STATE OF MAINE
DEPARTMENT OF TRANSPORTATION
16 STATE HOUSE STATION
AUGUSTA, MAINE
04333-0016

May 6, 2010
Subject: **Bradley**
Federal Project No: BH-1668(700)X
State Pin No: 016687.00
Amendment No. 2

ARCH ELEVATION

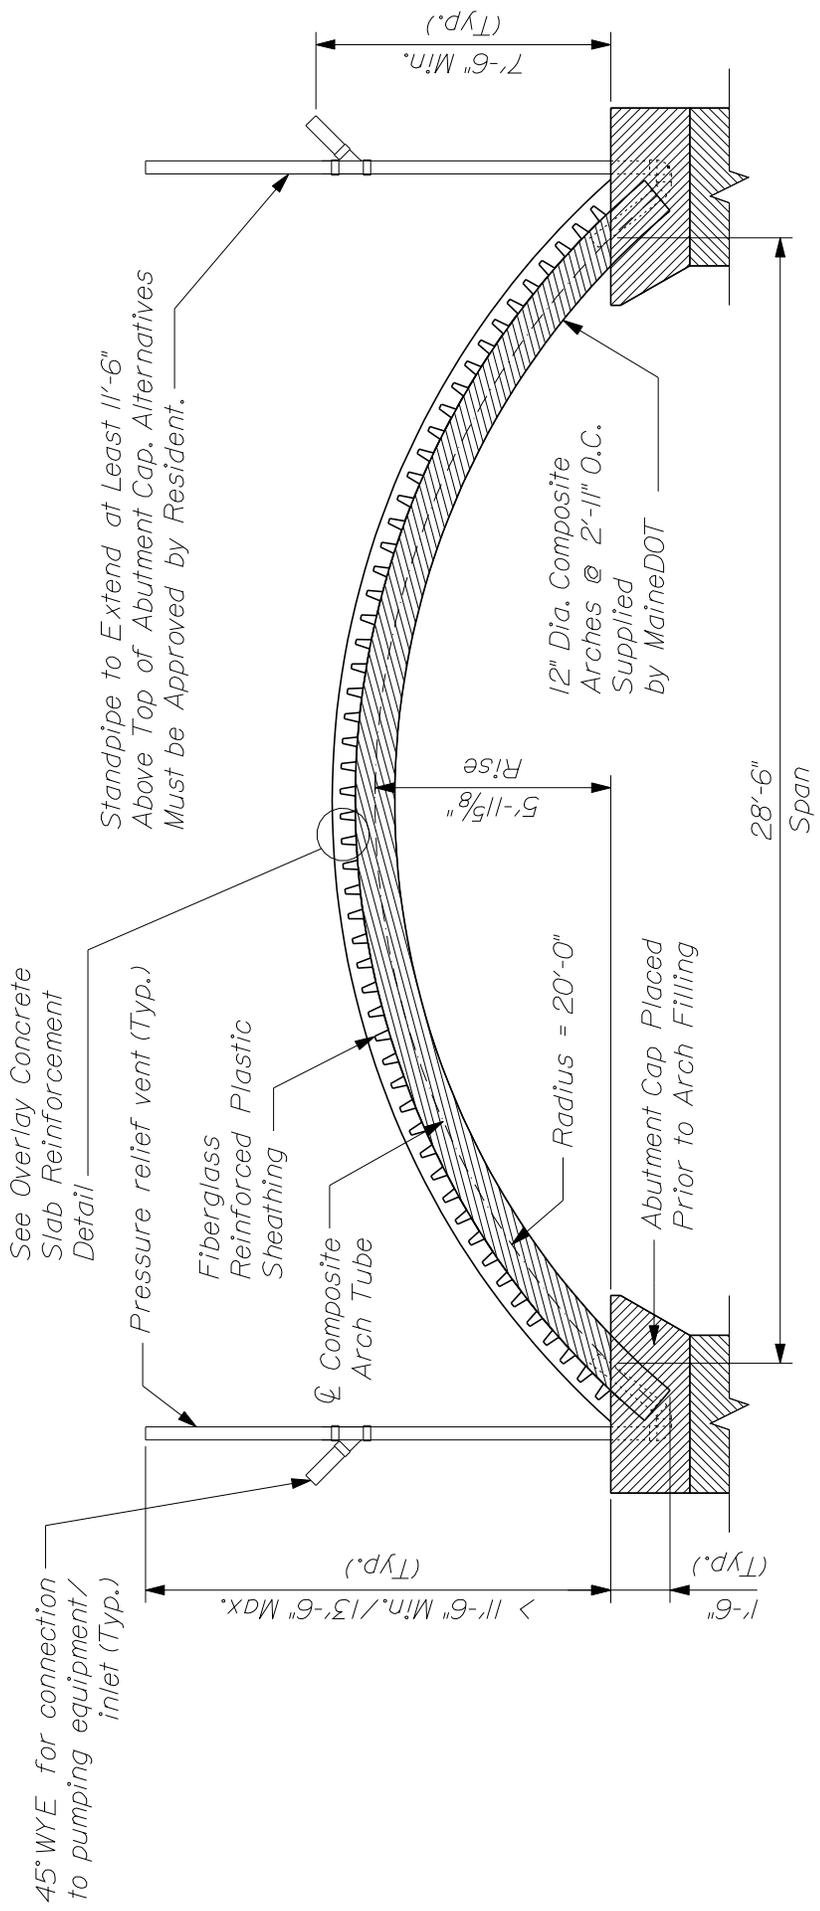
In the Bid Book, after page 76, **ADD** the attached "ARCH ELEVATION" (one page) after the last page of "SPECIAL PROVISION, SECTION 509 COMPOSITE ARCH SUPERSTRUCTURE ERECTION (Installation Only)".

NOTE: The standpipe configuration shown in the elevation shall be considered an approved alternative to the one shown on Plan Sheet 15 of 18.
